Addendum No.1
to
CONSTRUCTION DOCUMENTS
for

May 21, 2025
2023159.00

NCISD New District Administration Building
21330 Valley Ranch Parkway
New Caney, TX. 77357
May 20, 2025

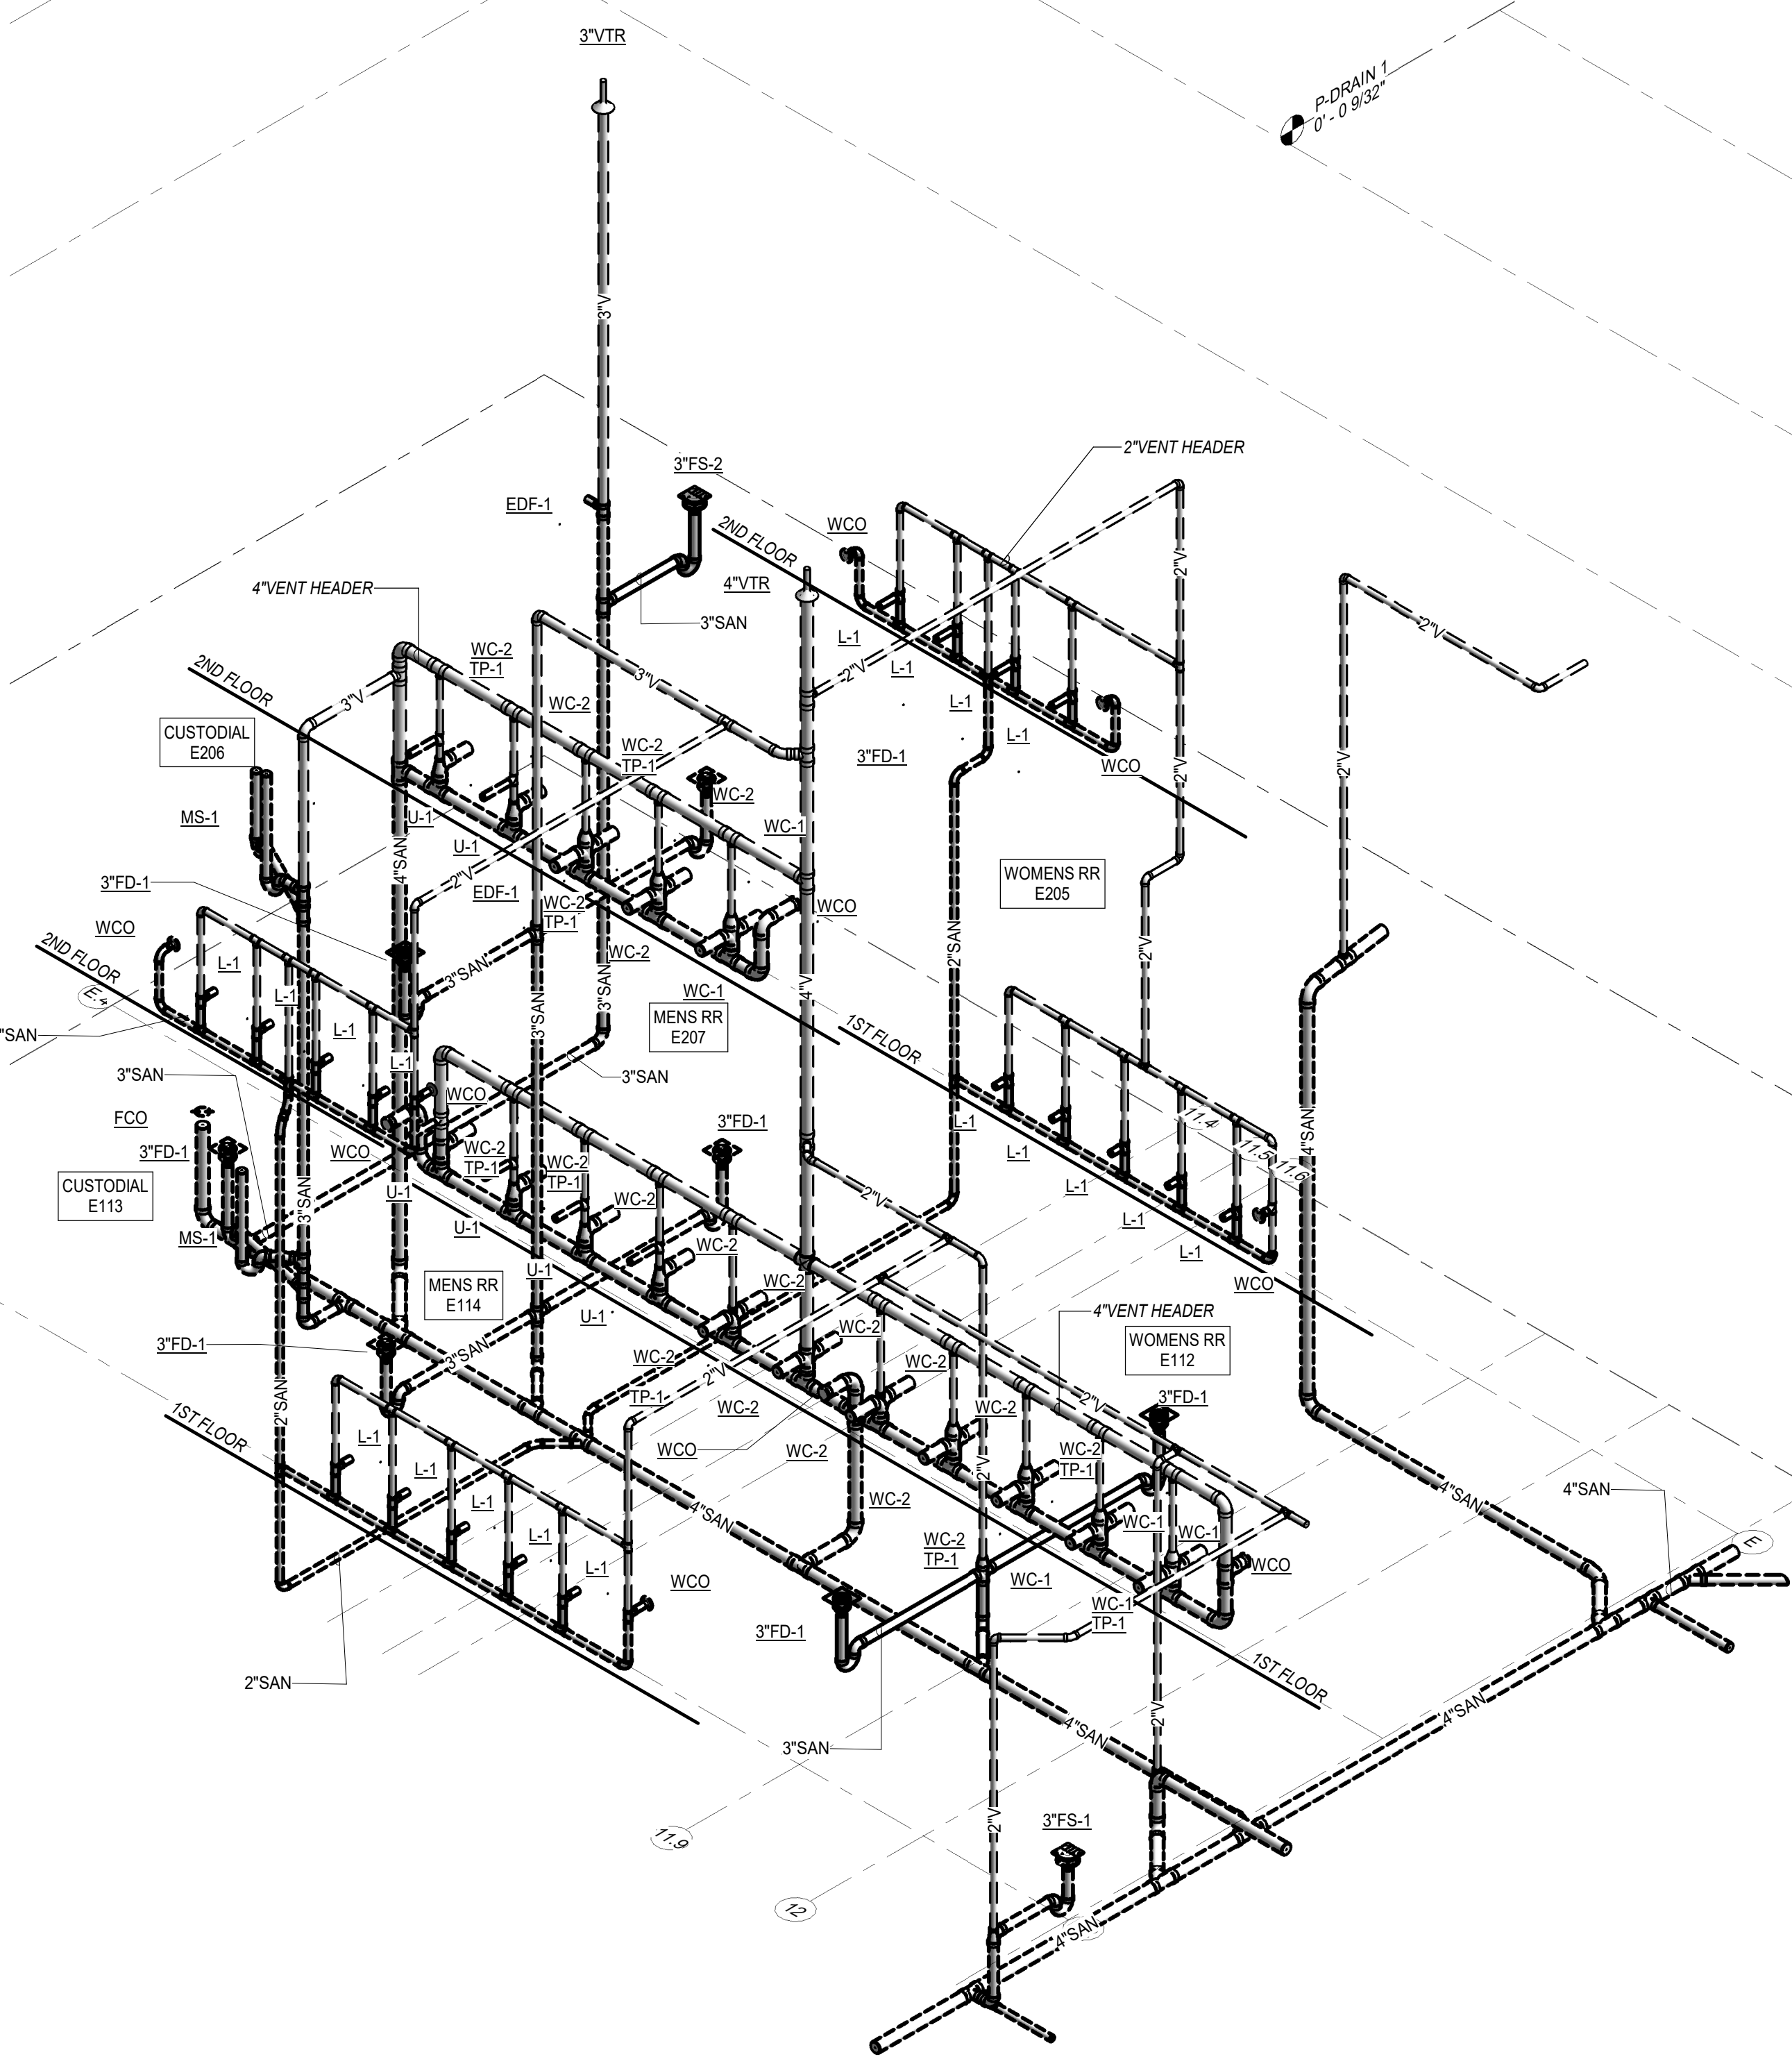
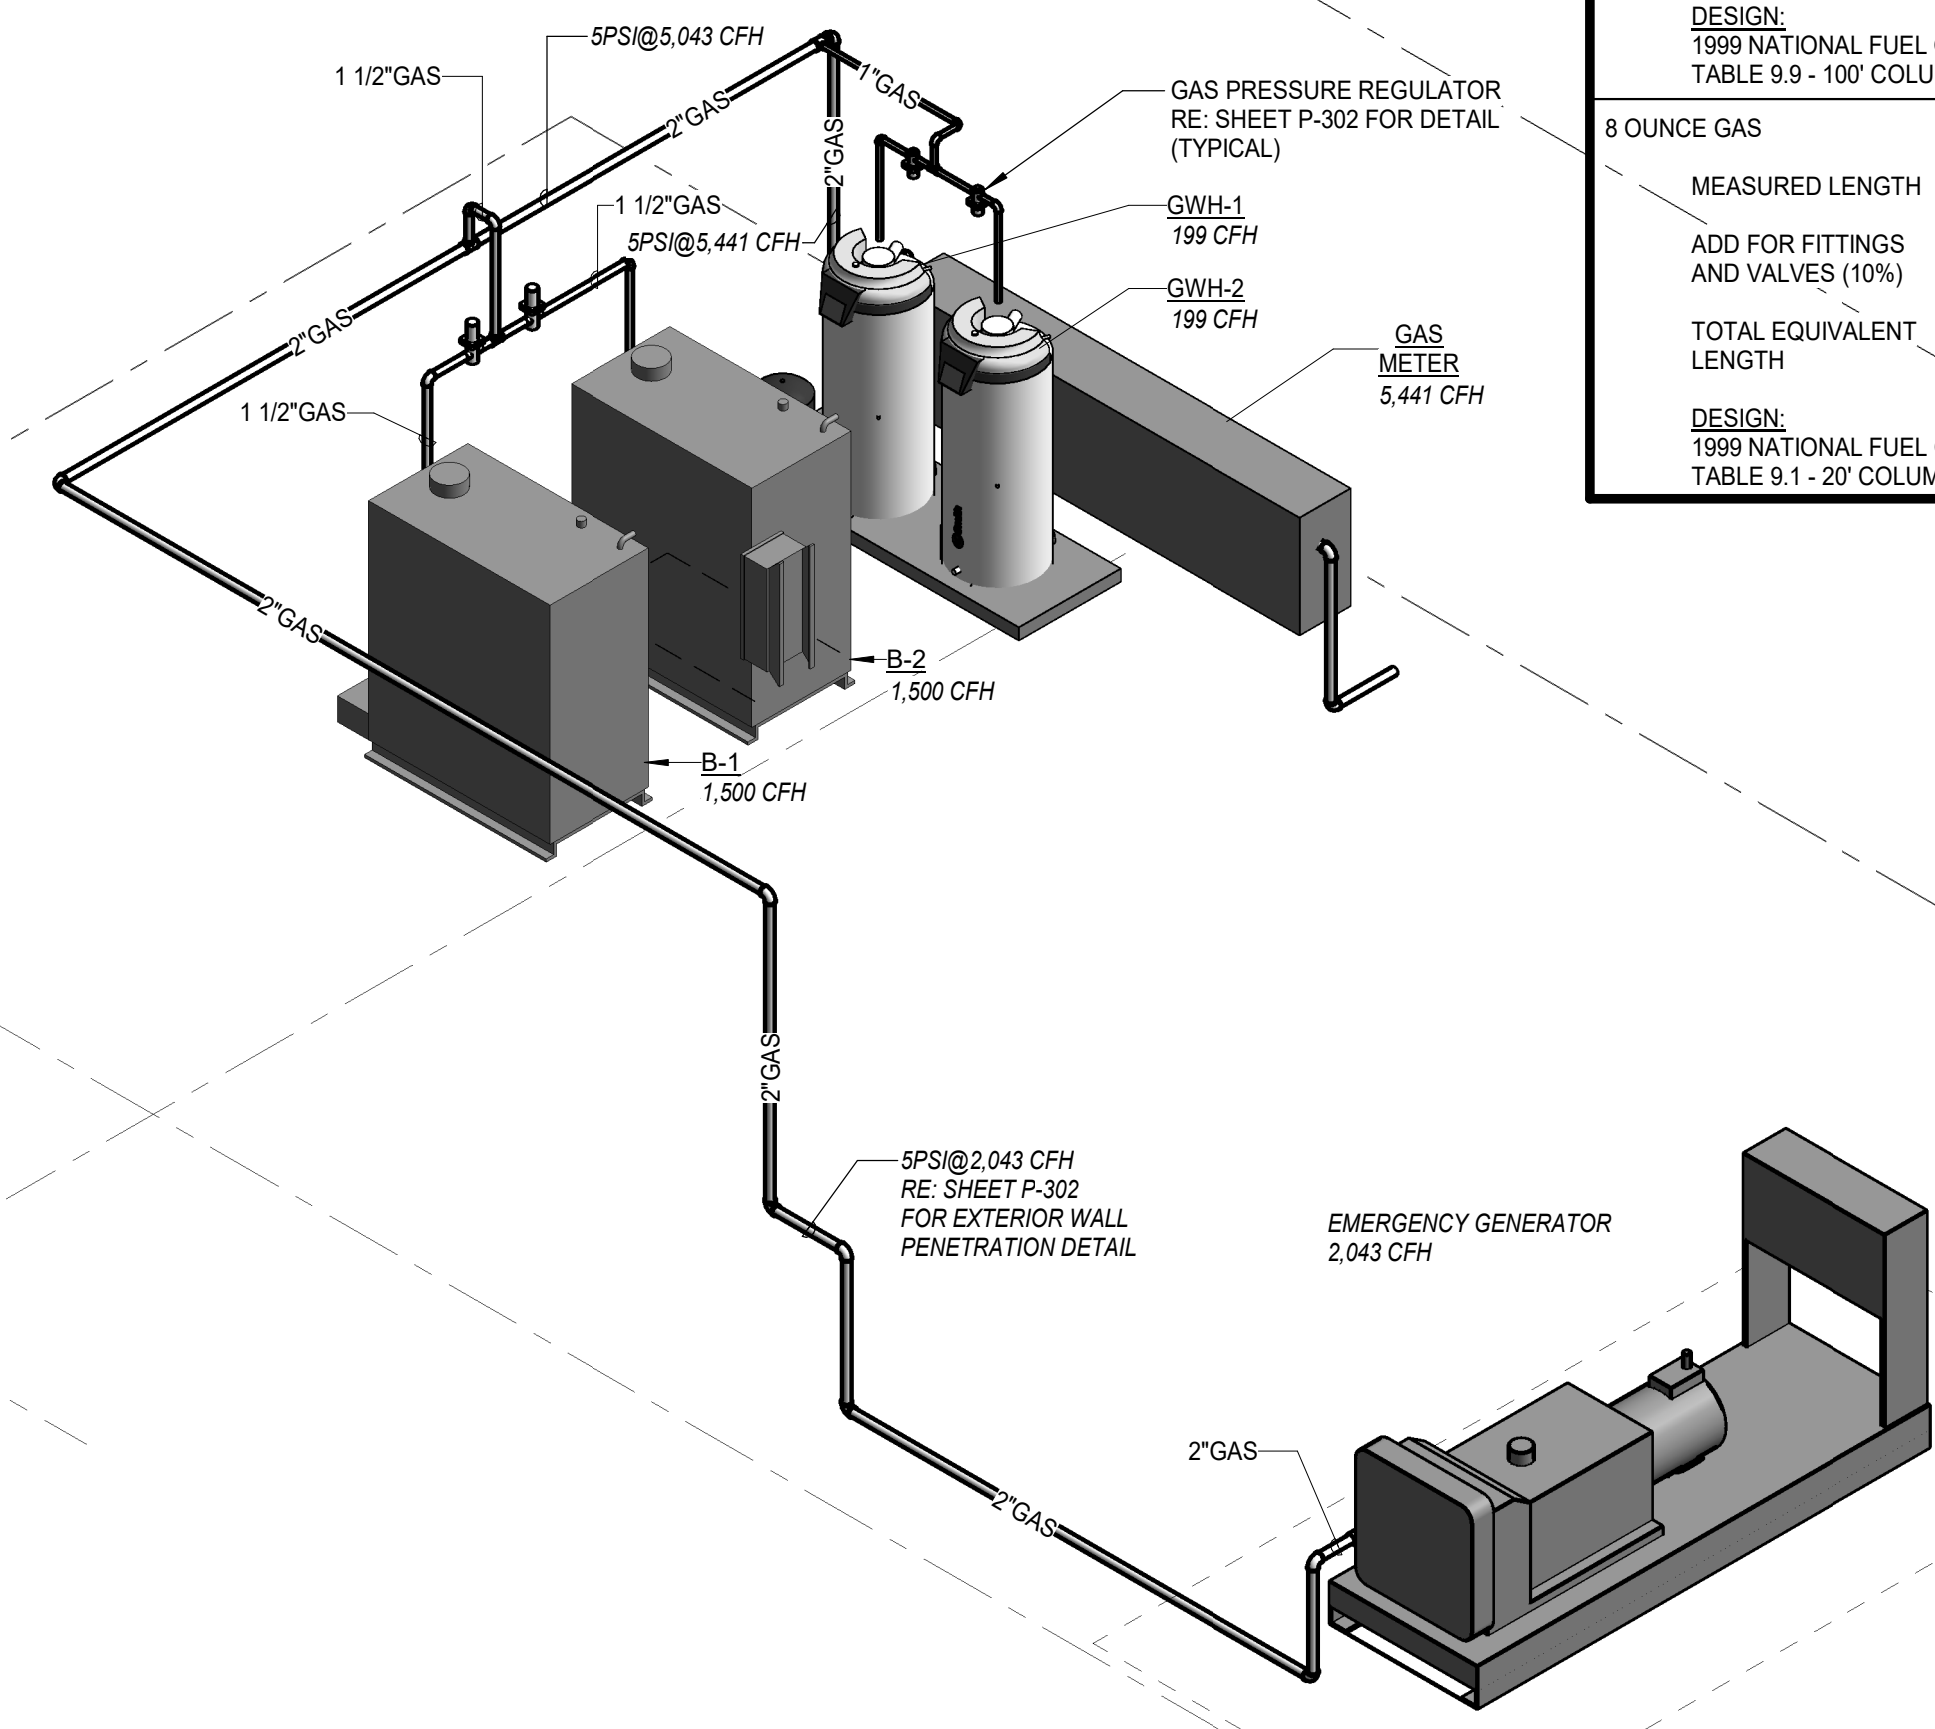
NEW DRAWING SHEETS

1. P-501- PLUMBING RISER DIAGRAMS
 - a. Add sheet in its entirety.
